To: Dave Larsen[dlarsen@reiengineering.com]; Egan, Robert[egan.robert@epa.gov]; KHanson@ldftribe.com[KHanson@ldftribe.com]
Cc: Kamke, Sherry[Kamke.Sherry@epa.gov]; Kady, Thomas[Kady.Thomas@epa.gov]
From: Saari, Christopher A - DNR
Sent: Wed 11/9/2016 6:57:52 PM
Subject: RE: Recommendations for additional well locations at the Tower Standard site
removed.txt

From: Egan, Robert [mailto:egan.robert@epa.gov]
Sent: Wednesday, November 02, 2016 8:08 AM
To: KHanson@ldftribe.com; Saari, Christopher A - DNR; Dave Larsen
Cc: Kamke, Sherry; Kady, Thomas
Subject: Recommendations for additional well locations at the Tower Standard site

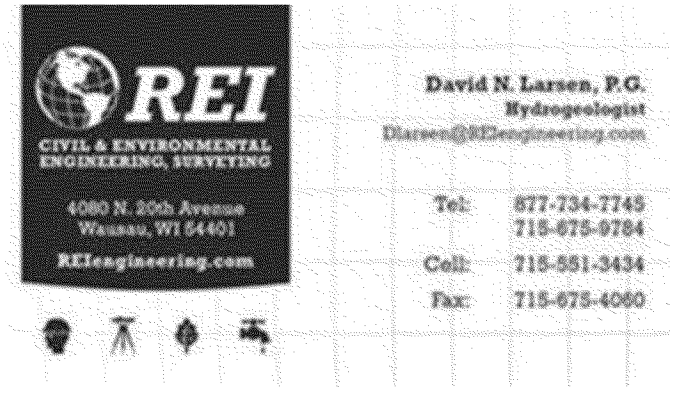
Thanks for the information. My locations were just to get the discussion started. I remember there also being a VAS location west of the 16 well nest and that the plume seems narrow in that area. I think we can all talk about whether there is a need to have wells near the edge of the plume. With the medium and deep wells at 16 being highly contaminated we would normally put wells outside this area but there is previous information in that area that shows that contaminant levels quickly drop off to the west.

Bob, I attached figures depicting locations of the MW13 well nest from the initial investigation along with summary lab tables. Is this sufficient to close the data gap west of MW16? I know the data is 10+ years old, but may be useful. The shallow well (13s) was screened from 33-28' and the deep (13d) was screened from 50-45'.

I would concur with these suggestions, and would add a shallow well to the nest proposed between MIP3 and MIP13, for data consistency purposes.

Here are some suggestions for locations to fill in gaps in the well network:

1. A background well nest near Highway 70 with shallow and mid-depth range wells.

2. Shallow and mid-depth range wells at a location south and east (about 30-40 feet) of the MIP2 location.

3. A location between MIP13 and MIP3 where contamination is at depth. Mid-range and deeper wells.

4. If access is possible, wells near the MIP14 location. Shallow, mid-depth and deep.

5. A location somewhere to the west or northwest of the MW16 wells to try to find the edge of the plume in that area. Shallow, mid-depth and deep.

Assumed well depths:

Shallow wells: 15' depth with 10' screen lengths

Mid-Range: 40' depth with 5' screen

Deep: 60' depth with 5' screen. Well location #4 – well to be screened from 55-50' based on MIP data.

#4 location may need to be drilled with an ATV rig – I will need to discuss with drillers.

All PZ's to be blind drilled and grouted and MW's are to be logged.
